Re: Site Servicing Review
Additional Discussion
215750 Concession 4
Conc. 4, Pt Lot 22
Township of Chatsworth

This letter is further to our Site Servicing Review (dated January 11, 2018) and provides additional discussion based on comments received during the public meeting on April 18, 2018.

CONCEPTUAL SITE PLAN

Figure No. 1

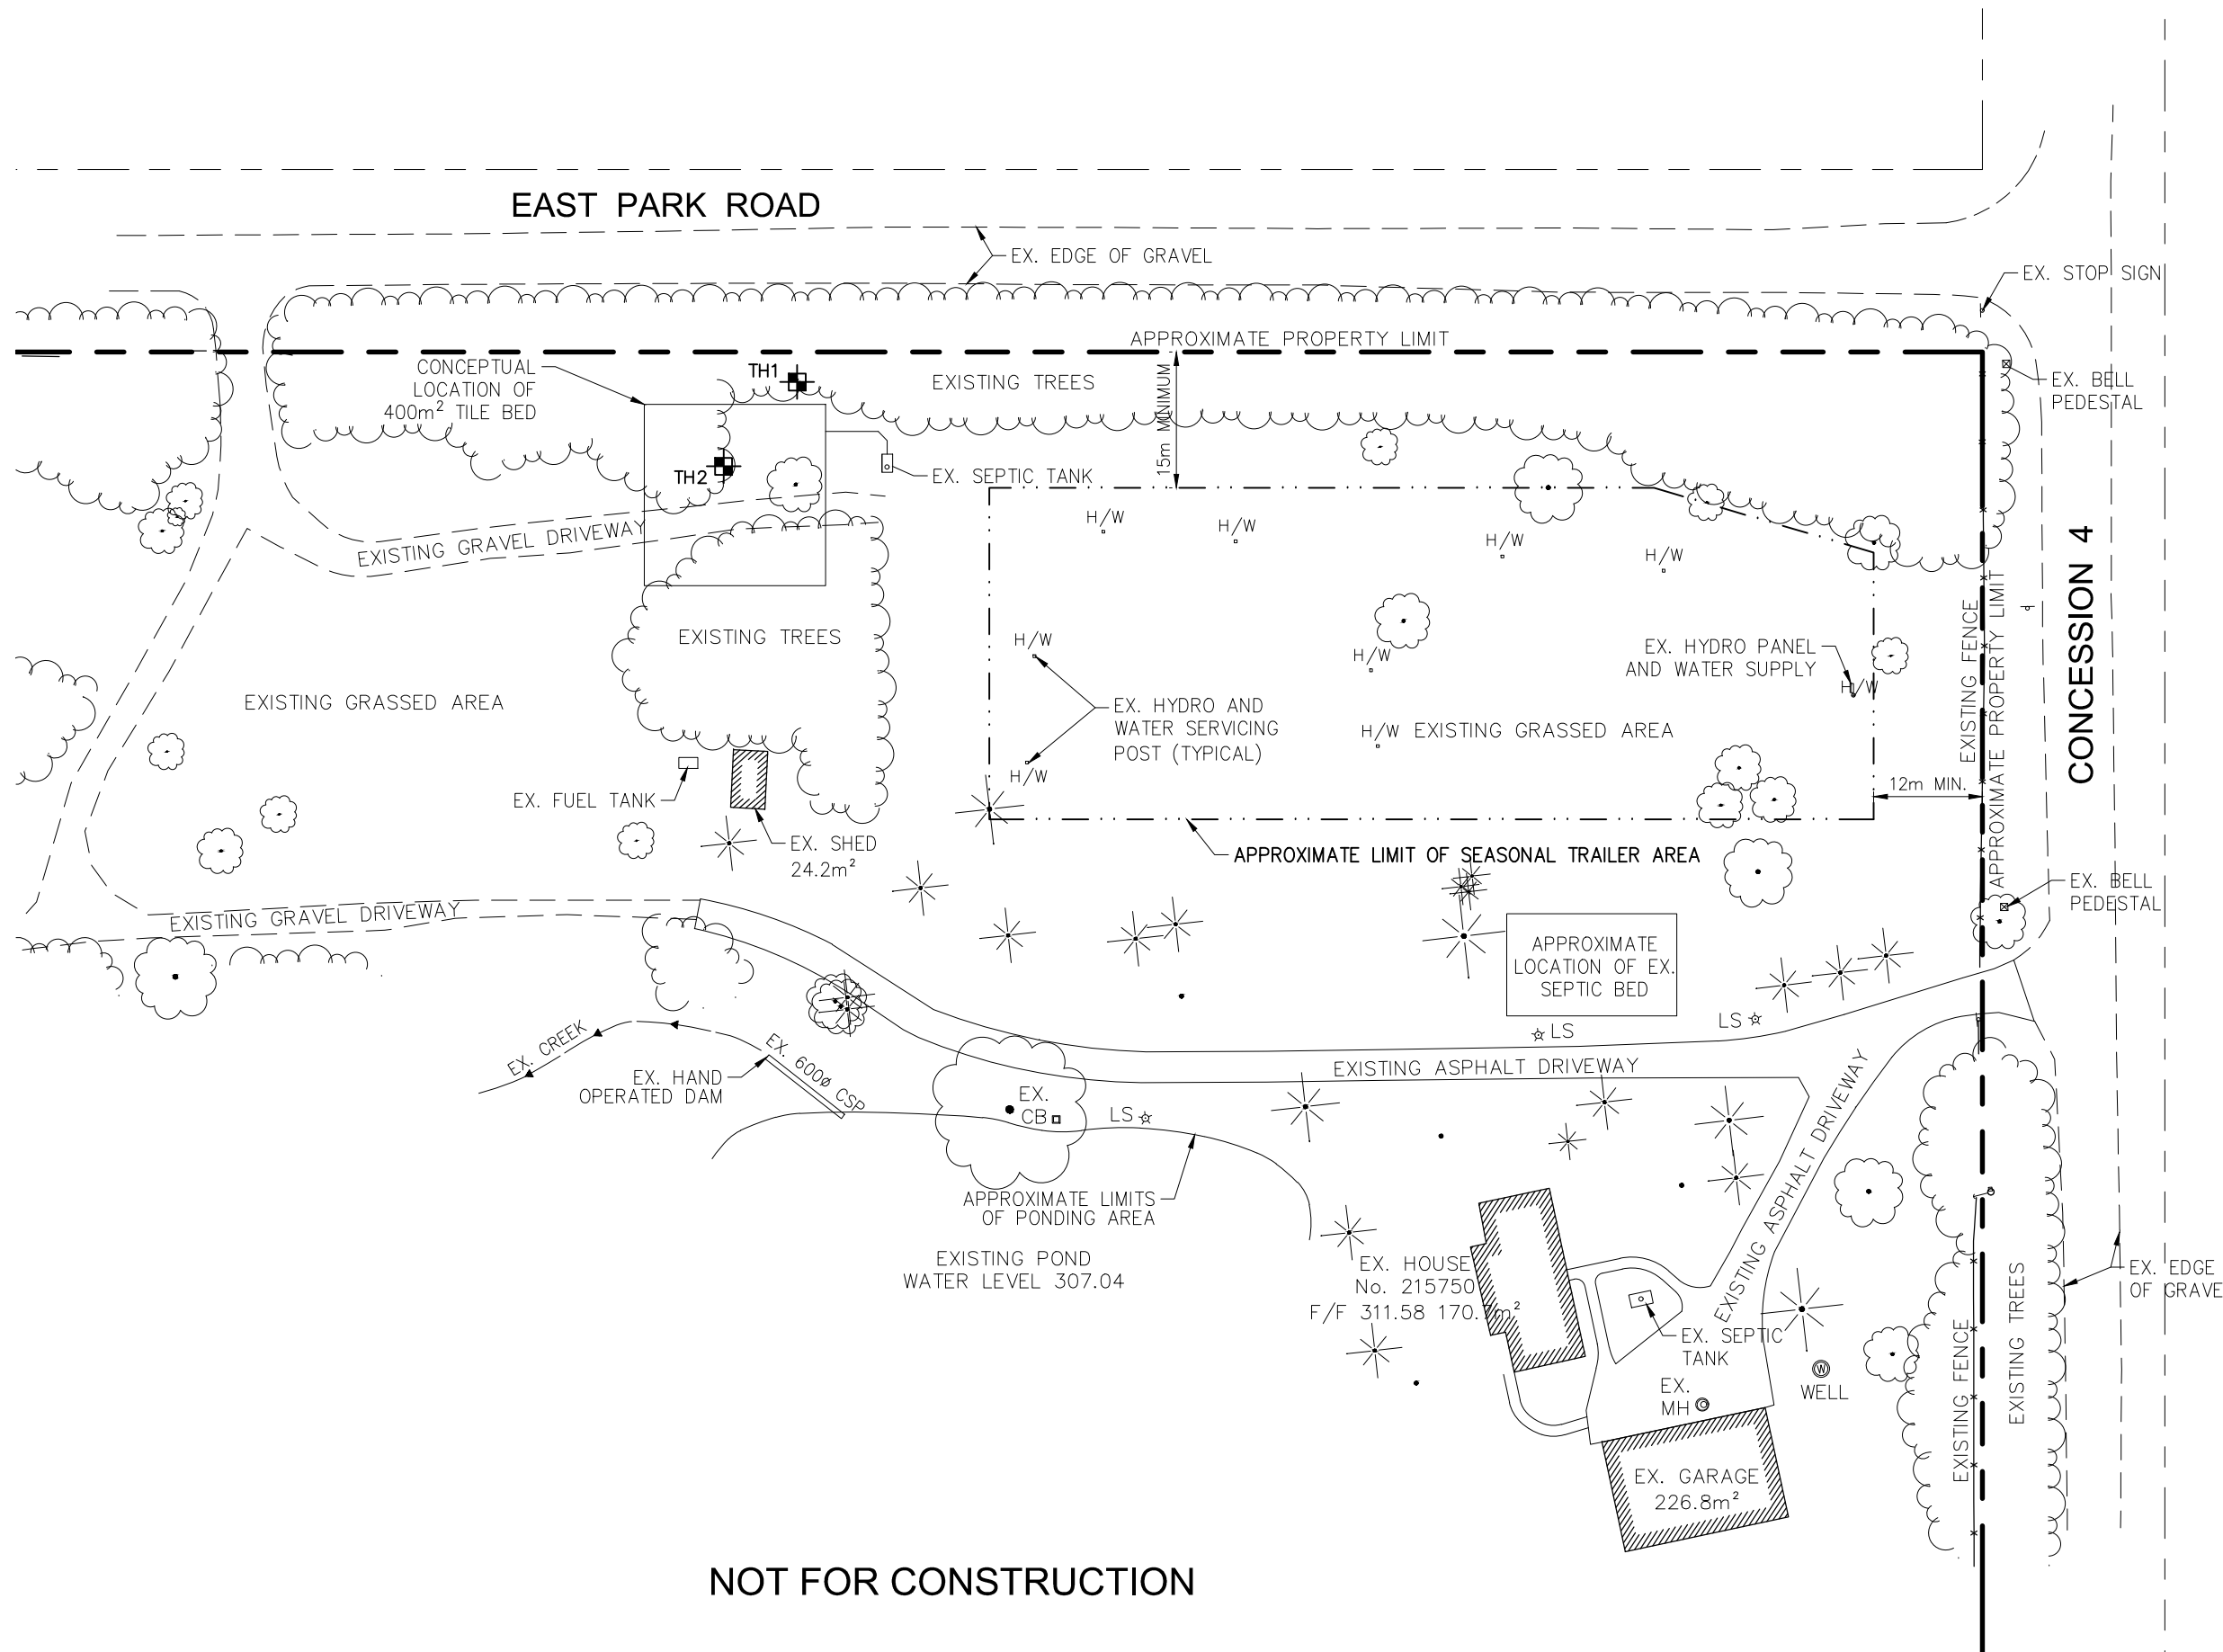
It appears that there was also concern regarding the lot's ability to site the proposed sewage system's tile bed. Based on calculations, the tile bed would require a total area of 385 m². This bed area includes the mantle, which may be of native materials where soil conditions permit. The current soil conditions meet the requirements for use of the native soils to achieve the mantle.

A review of the proposed location of the tile bed has been completed. A conceptual layout is enclosed. The set-backs under the OBC can be met. As per planning staff comments, the tile bed will be located fully in the area proposed by re-zoning. Under this review, the locating of the sewage system on the lot is not considered to be a constraint for the proposed development.

From the practical perspective, the reduced area described above (3 ha) development area can easily accommodate the sewage system infrastructure and the dilution area. As per the discussion above, the sewage system sizing is similar to that of 2.4 residential homes, and the reduced area provides for over 1 hectare per home equivalent in which to accommodate a tile bed. The locating of a tile bed does not typically become constrained unless lots are highly irregular in shape or smaller than approximately 0.4 hectares (1 acre).
